31/07-04I 10109 Grant Ave
Capitol View Park Historic District

MEMORANDUM

SUBJECT: Historic Area Work Permit # 359263 10109 Grant Avenue, Silver Spring, Capitol View Park Historic District

HISTORIC PRESERVATION COMMISSION STAFF REPORT

HOUSE LOCATION DRAWING

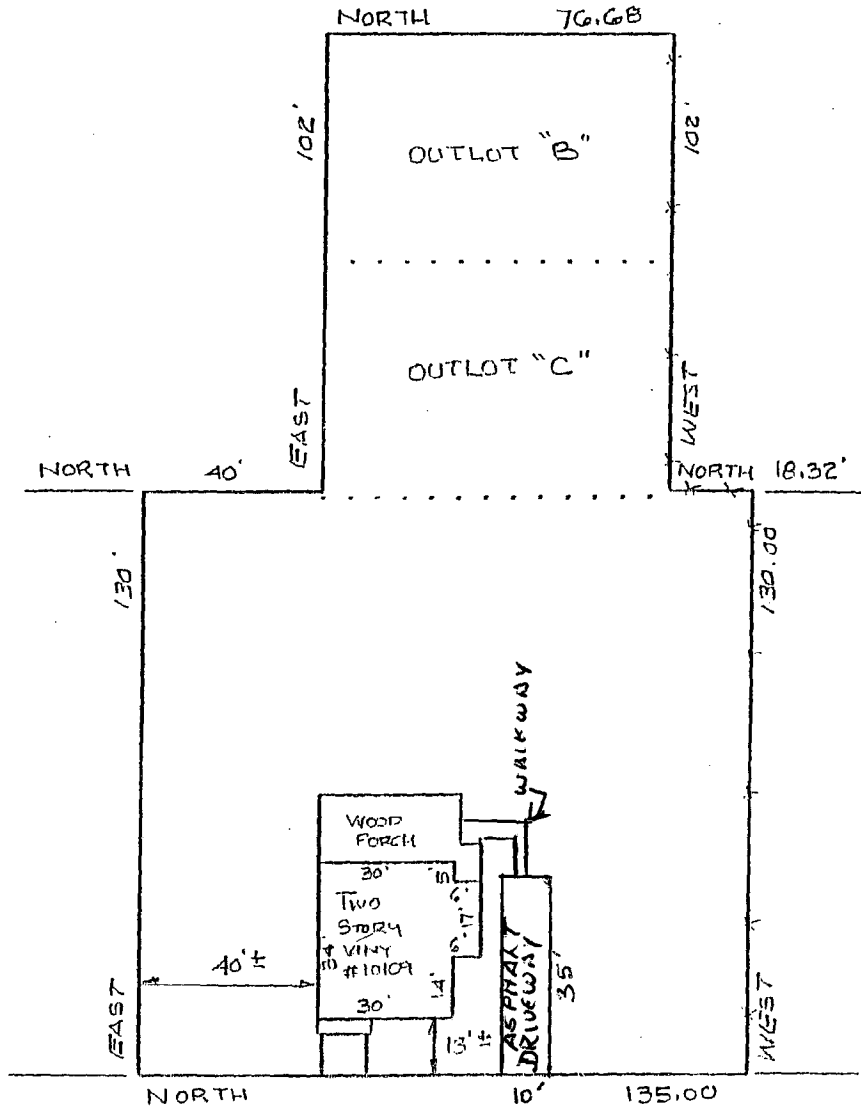
Proposal Item #3 Installation of a 35' x 10' asphalt driveway along the south elevation of the house to provide off-street parking.

Typically the Commission only approves the installation of new driveways on outstanding resources that are constructed with gravel. Additionally, a large evergreen tree is located in the path of the proposed driveway and its removal is not included in this proposal. Staff would ask the applicant to provide the Commission with details about this driveway, including a scaled, site plan identifying existing trees to be retained and the trees to be removed as part of this project. For any tree, whose critical root zone is to be affected by the installation of this driveway, a tree protection plan must be drafted by a certified arborist and submitted to the Commission for their approval. As such staff would recommend that the current driveway proposal be continued until further documentation can be provided to the Commission.

Proposal Item #4 Install a concrete walkway from the rear of the driveway to the back steps, which leads to the back door of the house.

Staff does not object to this design in concept, yet, would recommend that the Commission defer their vote on this aspect of the proposal until such time they make a decision regarding the driveway, since the design of the sidewalk is affected by the construction of the driveway. Additionally, staff would ask that the sidewalk's location and dimensions be illustrated on the above requested site plan.

2. Applicant will receive staff approval of the wood, trim's profiles prior to its installation on the house.
3. The proposed driveway and walkway projects will be gravel and the locations to be worked out by staff.

2. Applicant will receive staff approval of the wood, trim's profiles prior to its installation on the house.
3. The proposed driveway and walkway projects are not approved.

EXHIBIT H

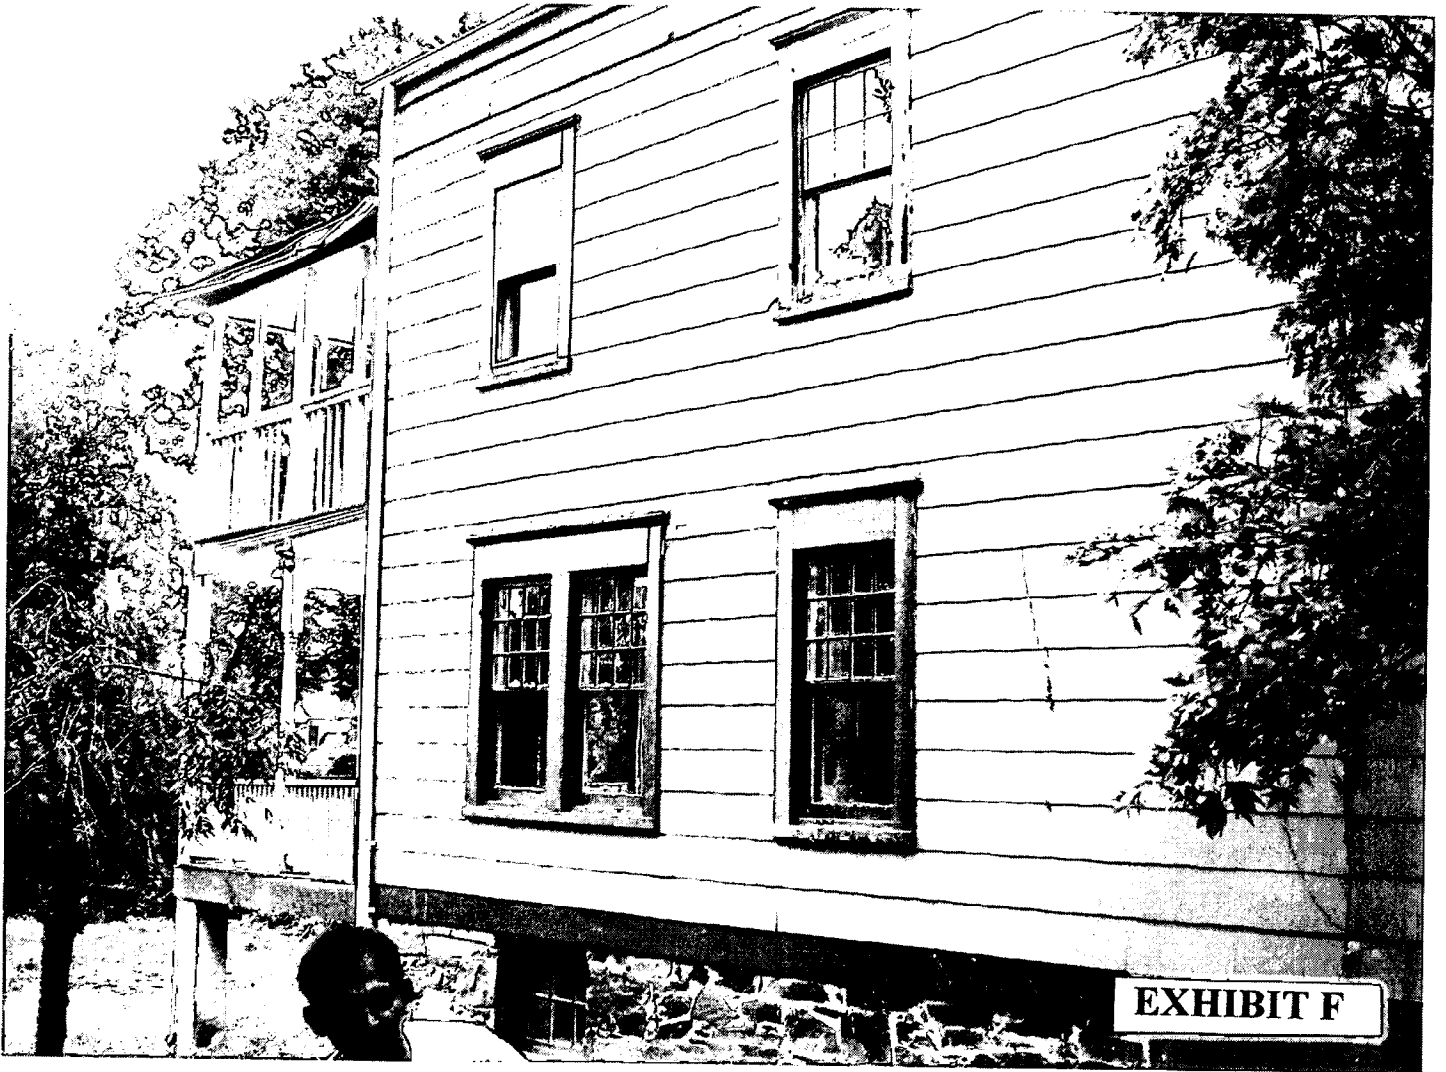
Proposal Item #2 Replacement of exterior, wood trim where deterioration is evident.

A twin of this house, built at the same time and with very minimal changes is located at 10245 Capitol View Avenue. This house should be used as a resource when developing specifications for replacement trim for this house. The entablature above each window, the trim around the doors and windows and the cornice detail are important character defining features of this house. Adding conjectural features to a house, namely different size and profiles of details such as trimming, can be detrimental to the historicity of the house. As such, staff recommends that the applicant work with the Commission's staff to ensure that the specifications for the trimming installed reconstructs these original elements. Again, the cost of the fabrication of these details, the installation of the trim and the painting are eligible for the County tax credit.

RAISED
6-PANED
DOOR

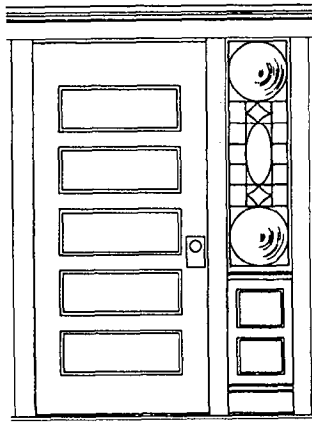
Proposal Item #5 Replace the existing non-historic metal front door with fanlight detail with a raised panel, wood (birch, maple or mahogany) door with fanlight detail.

Staff strongly supports the applicant's desire to install a more sympathetic door onto the front façade. The fanlight, design however, is not a traditional design that would have been found on a house of this period. The fanlight design incorporated into a door is a contemporary interpretation of the Federal Style, six-panel door with fanlight transom. As such, staff would recommend that the applicants install a door, which would have been more of the period, such as a painted, raised, six-paneled door or a raised 5-paneled door (see examples on circles 29+30).

4. The basement windows may be replaced with fixed or hopper, wood, 6-light windows.
5. The new front door will be either a painted, raised, five or six-paneled wood door.
